Bombay Commercial Vehicle Safety Centre – Response to Section 92 RMA Request for Further Information

To	Michele Schitko-Saboonchi and Vanessa Leddra, Auckland Council
Copy	Belinda Petersen, Nitin Sahare, Burges Daruwala, Alisdair Simpson
From	Tina Kalmar
Office	Auckland
Date	18 March 2024
File/Ref	1-C1875.08
Document Code	5C4353-WRP-04-MM-PL-1002_Rev C (WSP-WRP-RFI-015)
Subject	Bombay CVSC Notice of Requirement and Resource Consent BUN60427410 - s92 Further Information Request 29 February 2024

Table 3 – Unresolved requests and Further Information responses

Figure 1 - Queue length of 88 meters with an additional 9 vehicles at the northbound offramp

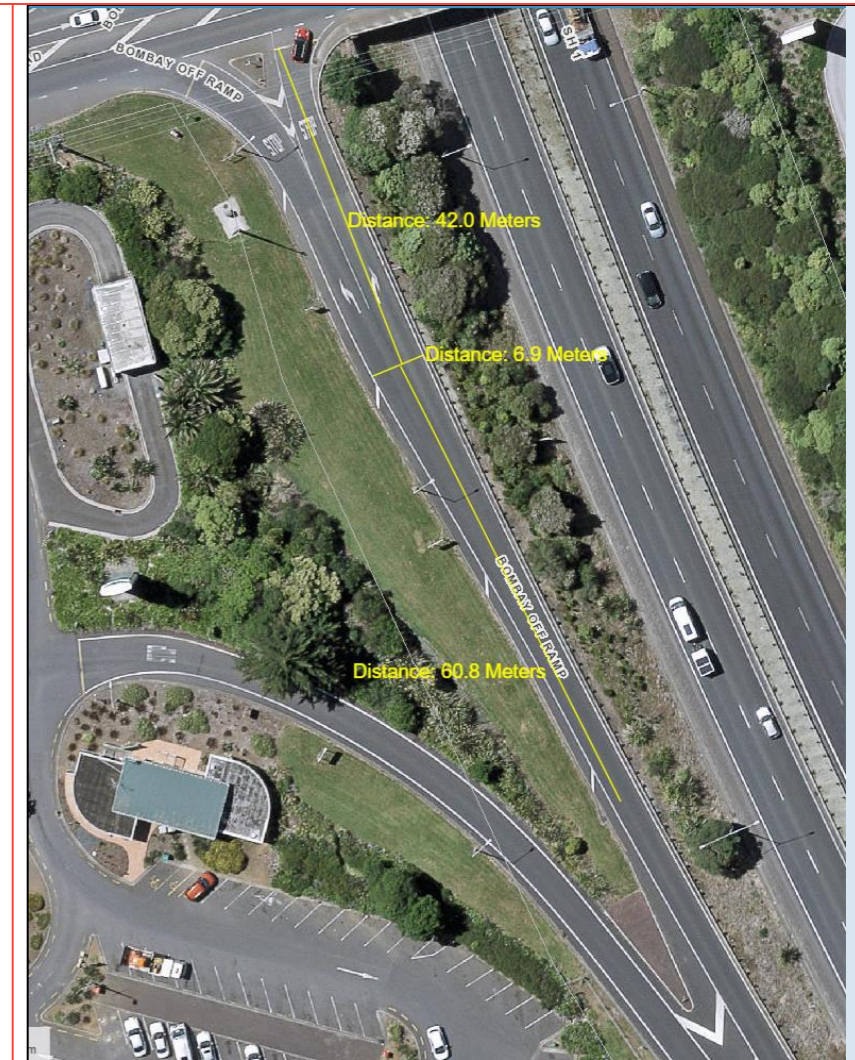
Item	Original Information request (30 November 2023)	Applicant's Response (26 January 2024)	Council further information request (29 February 2024)	Applicants Response (18 March 2024)
	<p>off-ramp and to include outbound trucks from the CVSC site.</p> <p>Provide an assessment of the operation of the SH1 interchange including the Great South Road / Mill Road roundabout with the revised modelling.</p>	<p>January 2024 in Attachment A, specifically response on p.11.</p>	<p>Modelling should be provided.</p>	<p>to ensure the data was updated to reflect the increase in HCV volumes since 2021. We also refer back to the RFI 12 response (and Table 1) for a description of this.</p> <p>As RFI 12 mentioned, up to 17 vehicles will be directed to the CVSC, which means an average of 8.5 HC vehicles in each direction (northbound/southbound) arrivals at the Interchange from SH1. A further desktop assessment undertaken by WSP to address RFI 16 confirms that an additional 9 traffic movements in the right turn lane of the northbound off-ramp will have a minimal impact on the operation of the SH1 interchange.</p> <p>The reasons for this assessment are described in following:</p> <ol style="list-style-type: none"> In Section 6.1.5 of the TIA report, the modelling result shows that with 6 additional vehicle movements in the northbound off-ramp, it will reach capacity and result in a queue length of 43 meters (Deg. 0.974). <p>Assuming 3 more HCVs are added in the right turn lane of the northbound off-ramp, the queue length may extend to 88 meters (43m +15m x3 HCVs) as illustrated in Figure 1.</p> <p>However, this queue does not reach the merging lane with the separated left-turn bypass, which is 290 meters away (as shown in Figure 2), nor does it affect the SH1 lanes, which is 535 meters from the stop lane (as shown in Figure 3).</p> <div data-bbox="2041 1711 2864 1801" style="border: 1px solid black; background-color: #e0e0e0; padding: 5px;"> <p>Additional 9 vehicles queue length of 88 meters:</p> </div>

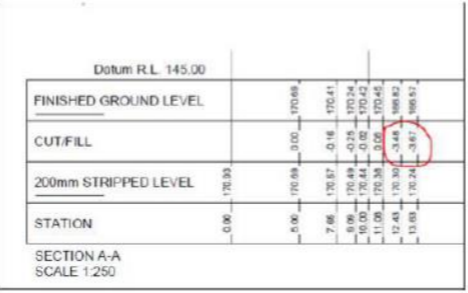
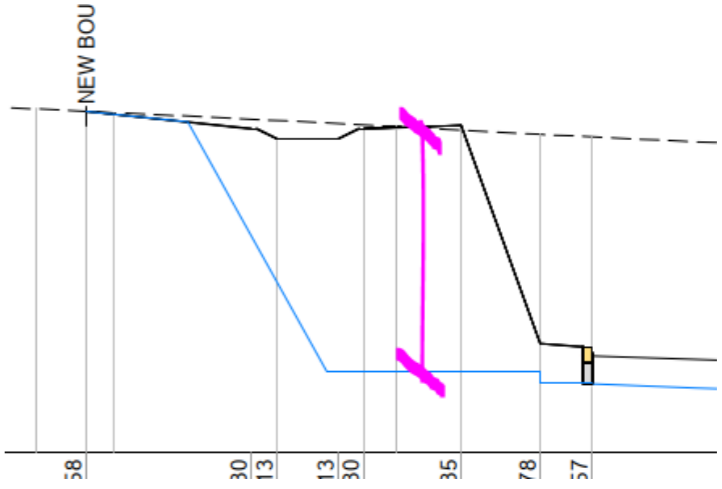
<p>43 [45 in SME's list]</p>	<p>If the proposed ESCP is to be retained in any form, please ensure that any non-GD05 practices are fully described in a technical report that demonstrates the likely efficiency of the device/s. I note the proposed two ESCP options do not clearly depict how it all works, ie what is the purpose of the Filter Socks? <u>Note:</u> Whilst the option to condition a Finalised ESCP is available, the</p>	<p>Refer to separate Memorandum dated 26 January 2024 in Attachment A., specifically response on p.26.</p>	<p>Outstanding as per the above.</p>	<p>Please refer to response to RFI 44 above.</p>

Item	Original Information request (30 November 2023)	Applicant's Response (26 January 2024)	Council further information request (29 February 2024)	Applicants Response (18 March 2024)
	indicative plan must be capable of being a final ESCP and any subsequent Finalised ESCP will need to meet the same standard or higher.			
Flooding (NOR/ RC)				
49 [5] in SME's list]	AEE, pg. 53 The AEE states that the depth of runoff from the site post-development is changed by 25.8mm for 100yr EDC case and 27.6mm for 100y MPD case. Please provide a proposed condition to ensure that the change in runoff will be appropriately managed to ensure the increase in depth of runoff is no more than as stated.	Refer to separate Memorandum dated 26 January 2024 in Attachment A. , specifically response on p.30.	<p>Unresolved as per feedback from HW's:</p> <p>For the catchment area upstream of the southern motorway culvert. The applicant's assessment indicates a flood level increase of less than 30mm because of the relatively steep contours an increase of less than 30mm does not increase flood extent in this area. An increase of less than 30mm in depth will be constrained by the topography of the area.</p> <p>Based on the information provided attenuation is not required.</p> <p>However, Tables 3 and 4 utilise a flood plain area of 28652m² for the 10 and 100yr events with and without climate change. Please review this number as we would expect different floodplain extent areas (+ floodplains) depending on event (10yr or 100yr) and whether climate change rainfall was utilised.</p> <p>Depending on the response to the question above further consideration may be required.</p>	<p>We understand the issue with the same flood plain footprint used as the basis for 100- and 10-year calculations presented in tables 3 and 4 of the Flood Assessment. If the flood level of 28,652m² is a plausible 100-year level (and it is) then using the same as the basis for the calculations for 10-year flood level increases overstates the floodplain area and diminishes the incremental depth calculated.</p> <p>We emphasise that without re-modelling the catchment to test the effect of the proposed development upon flood plains, the only information available from Geomaps is flood plain and flood prone area information which pertains to 100-year inundation. Geomaps does not give 10-year ARI flood plains and perhaps it was too coarse to use the 100-year data available.</p> <p>The flood plain area of 28,652m² used in the report to calculate increases in flood levels due to larger runoff volumes is based on a measurement of the 100-year flood plain within the 155.5mRL contour in Geomaps. This is a closed contour representing a ponding area which closely aligns with the 100-year Flood Plain. It is significant that the majority of the buildings (by area) in the vicinity of the flood plain lie outside the Flood Prone Area and Flood Plain. A lesser flood plain representing 10-year flooding (if one existed) would therefore show more buildings outside the flood plain.</p> <p>In light of the points made above, we suggest that the focus should be on 100-year effects as discussed in the</p>
